**STATE SIGNIFICANT DEVELOPMENT
ASSESSMENT REPORT:**

***Sydney International Convention, Exhibition and
Entertainment Precinct (SICEEP), Darling Square
(formally The Haymarket), South East Plot, Darling
Harbour***

SSD 6633

Environmental Assessment Report
Section 89H of the *Environmental Planning and
Assessment Act 1979*

Figure 8: Stage 1 Concept Approval maximum SE Plot building envelope (red) and the proposed development (Source: Applicant's EIS)

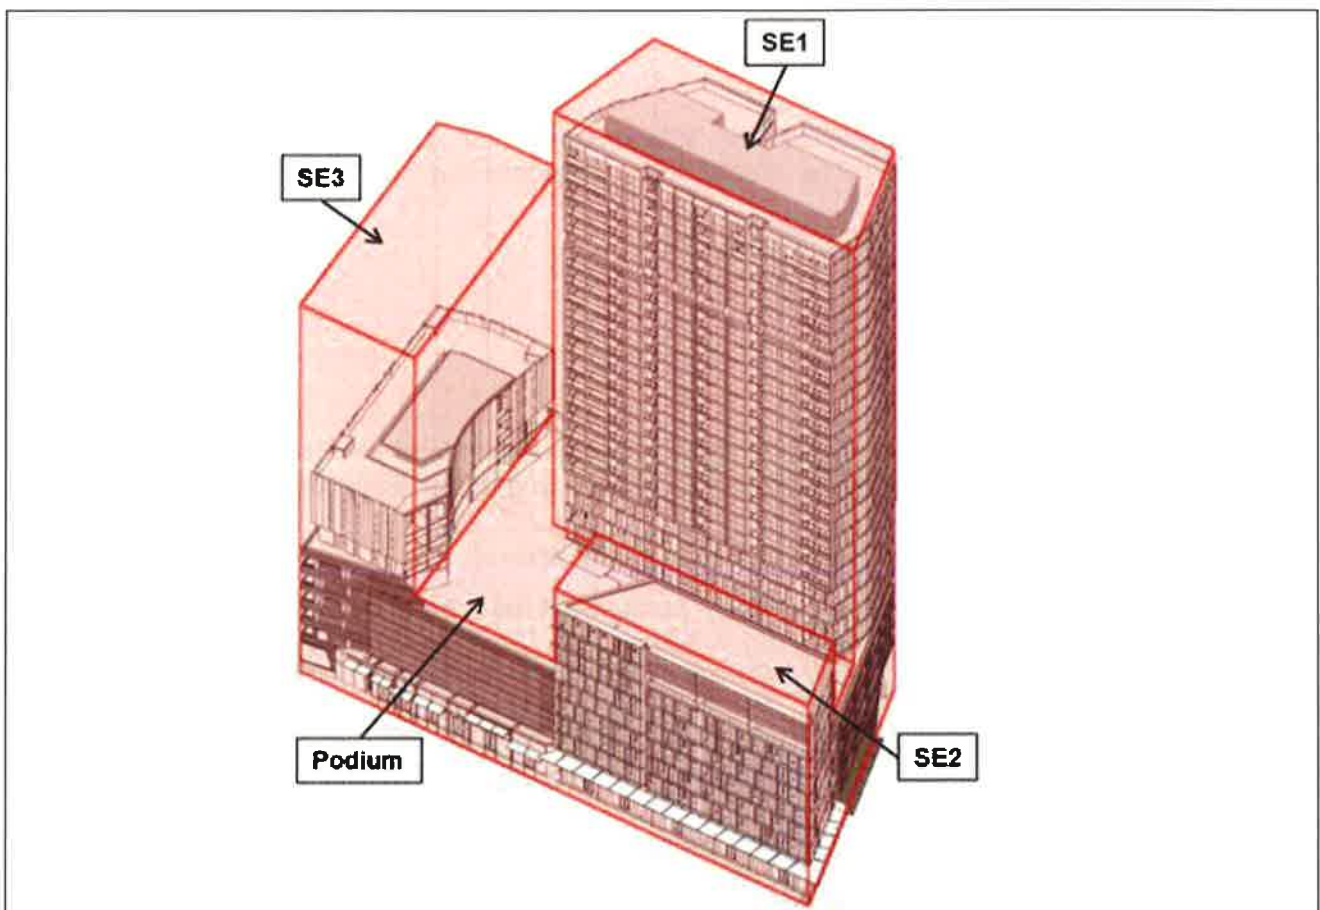
Council has raised concern that as the approved building envelopes for the SE Plot (and across the Darling Square precinct) are larger than the proposed buildings, there may be an expectation that these volumes be developed at a later stage via a modification application.

The EP&A Act allows the applicant to submit modification applications at any time. In the event a modification application is submitted, the Department would assess it on its merits, carefully considering the implications and impacts of the modifications and having regard to any issues raised in submissions.

The Department considers the proposed development fully complies with the Stage 1 Concept Approval parameters as outlined in **Table 8** and **Figure 8**. In addition, the Department notes the proposed lower height of the SE3 tower, when compared to the Stage 1 Concept Approval maximum building envelope, results in positive improvements to view sharing and solar access with the nearby residential apartments, including The Peak Apartments, and overshadowing of public domain.

Figure 9: The original ground floor level undercroft layout and elevation including the location of proposed uses and inactive areas, additional windows inserted by applicant outlined in green (Base source: Applicant's RtS)

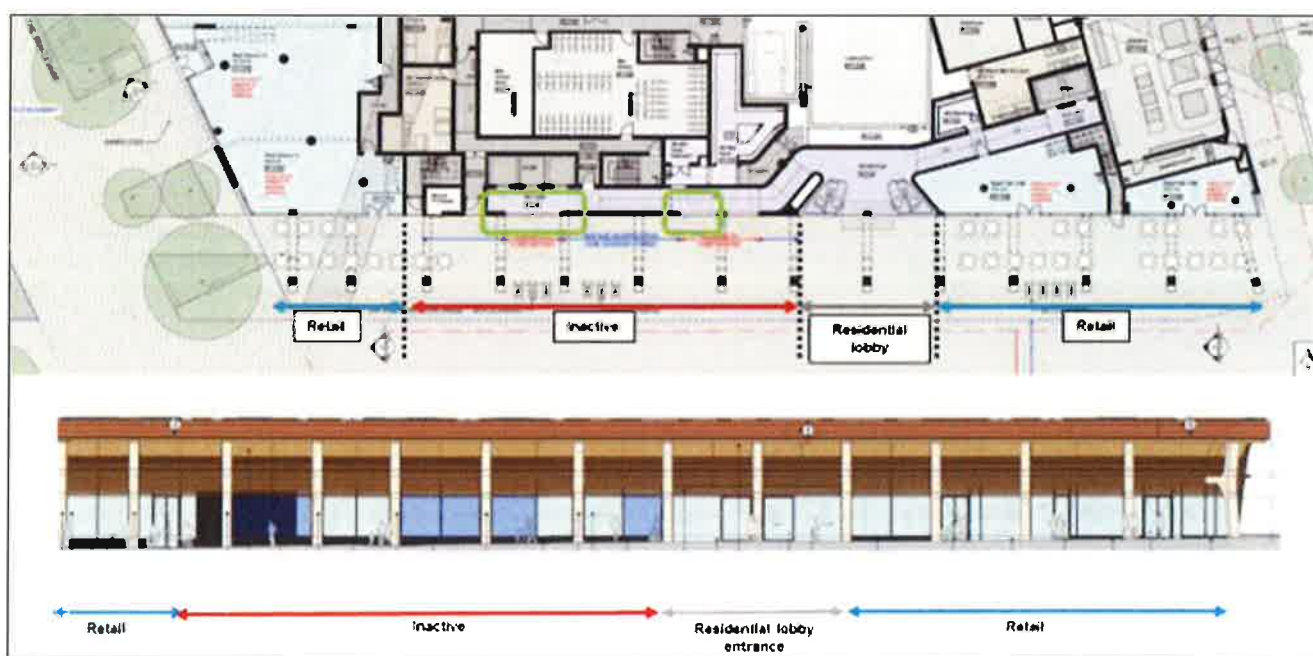
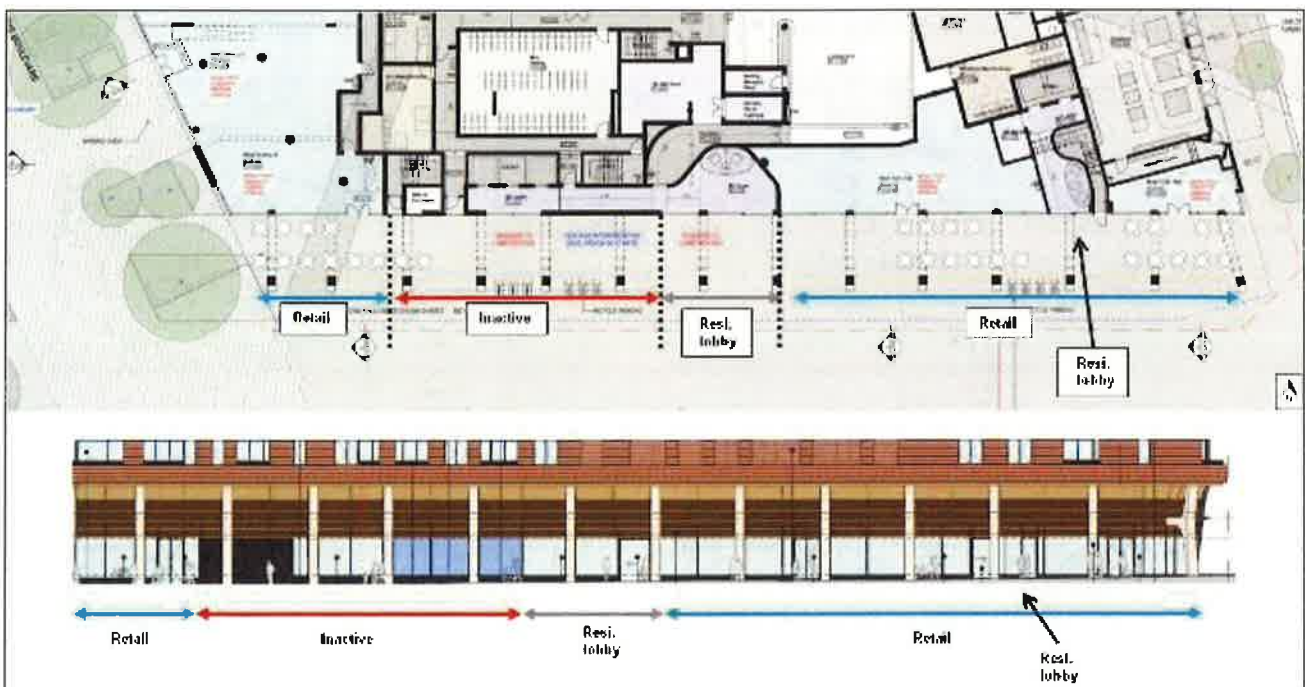
The proposal included a single residential entry point for the SE1 and SE3 towers. Internally the lift and stair-cores of both towers are linked via single long corridor (shown in purple in **Figure 9**).

The Department raised concern that a continuous length of 35 metres (41%) of the undercroft elevation would not be activated and this portion of the elevation is centrally located within the undercroft. Further, the residential lobby provides some level of activation, however, this is considered less intensive than a retail frontage.

In response, the applicant has amended the proposal by separating the shared SE1/SE3 residential lobby into two separate lobbies and included a large retail unit between the two lobbies as shown at **Figure 10**.

The Department notes the revised proposal has increased the width/frontage of retail units by approximately 12 metres (now occupying 60% of the total facade), increased the size of retail accommodation by 67 m² and created two residential lobbies with reduced internal corridor lengths.

In light of the above amendments, the undercroft elevation is now divided as described below (and shown at **Figure 10**):

- 51 metres (59%) of active glazed retail tenancy frontages;
- 10 metres (12%) of glazed lobby entrance; and
- 25 metres (29%) of blank wall / heritage interpretation and corridor windows.

The Department is satisfied the proposal has adequately responded to the concerns raised and will provide an appropriate level of activation within the undercroft area and internal residential amenity.

Figure 12: Solar access to the SE Plot, generally unobstructed solar access shown in yellow (Base source: applicant's EIS)

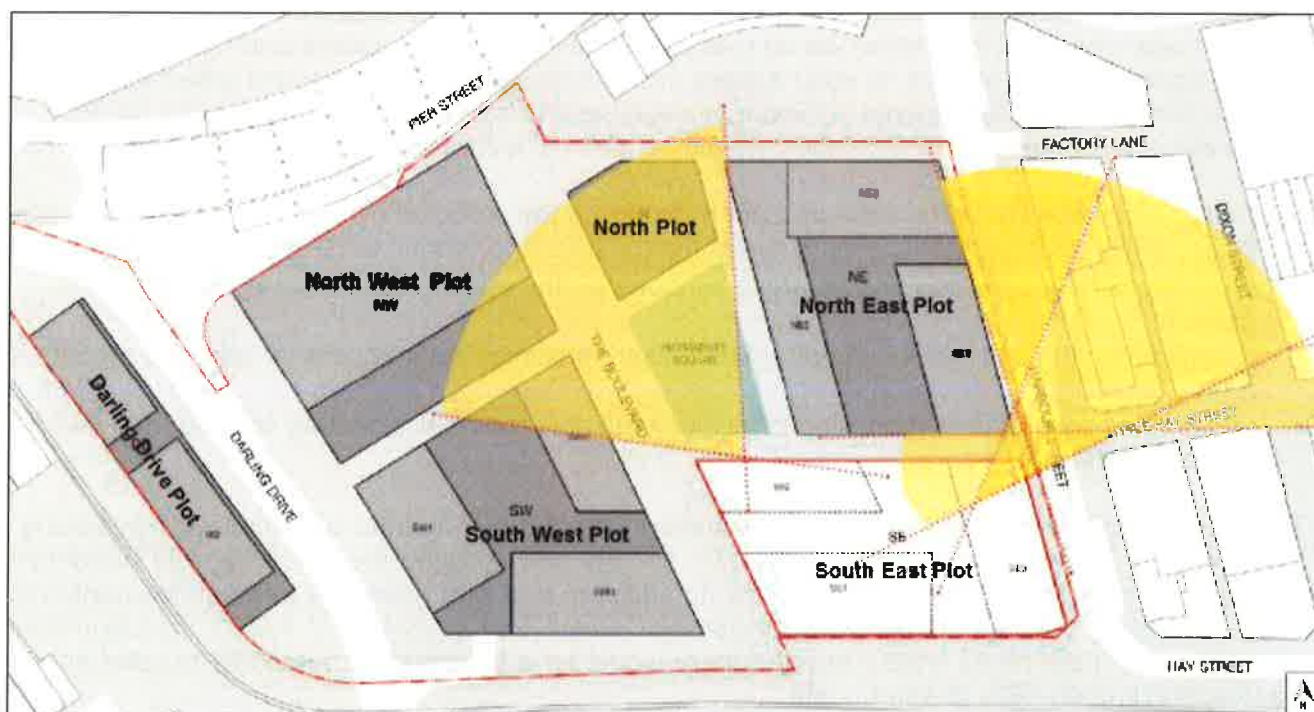
As originally submitted, the proposal did not meet the ADG's solar access recommendations as 183 of 391 apartments (47%) achieved two hours of sunlight and 34% of apartments received no solar access between the hours of 9am and 3pm midwinter.

The Department notes that achieving the ADG recommended level of solar access is difficult on the SE Plot for the following reasons (refer to **Figure 12**):

In response to these concerns, the applicant has revised the proposal by:

Figure 15: Building separation between the South East Plot and North East Plot buildings

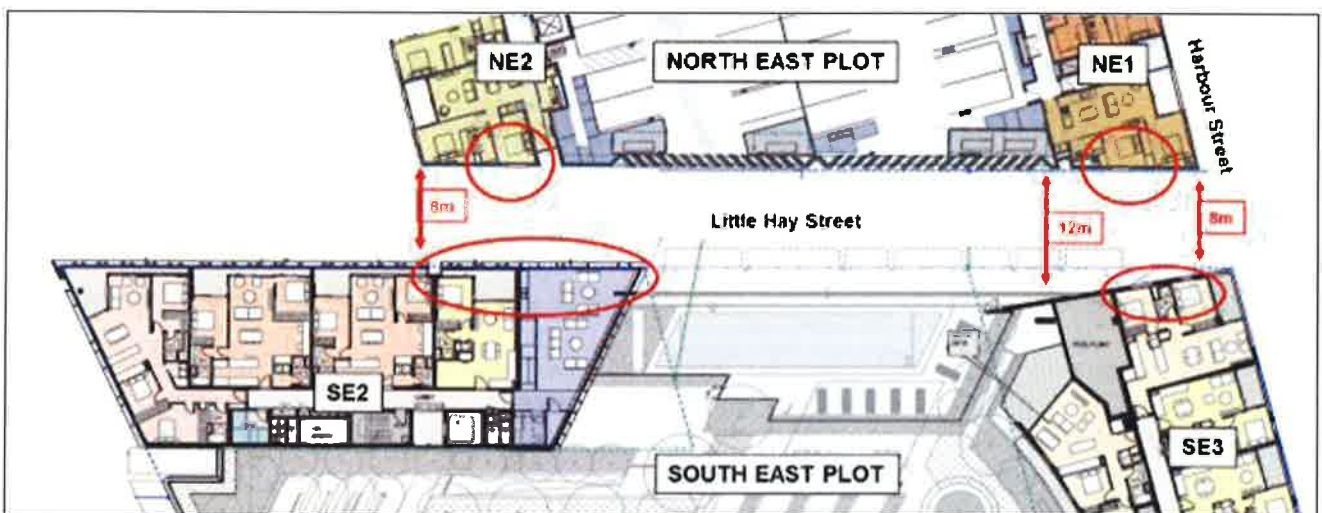
The Department is concerned the proposed internal layout would result in overlooking in the following locations (refer to **Figure 15**):

In response to the concerns raised, the applicant has confirmed that privacy screens or opaque glazing would be included to the bedroom windows of the affected apartments in the North East Plot development to the north (bedroom windows circled in red at **Figure 15**). The applicant has provided a letter of undertaking that the window treatments would be included as part of a forthcoming Section 96 modification application for the North East Plot.

To ensure an appropriate level of privacy is achieved, the Department recommends a condition that requires the windows of the apartments at each level be treated/screened to prevent direct overlooking, unless this has already been achieved via modification of the North East Plot development.
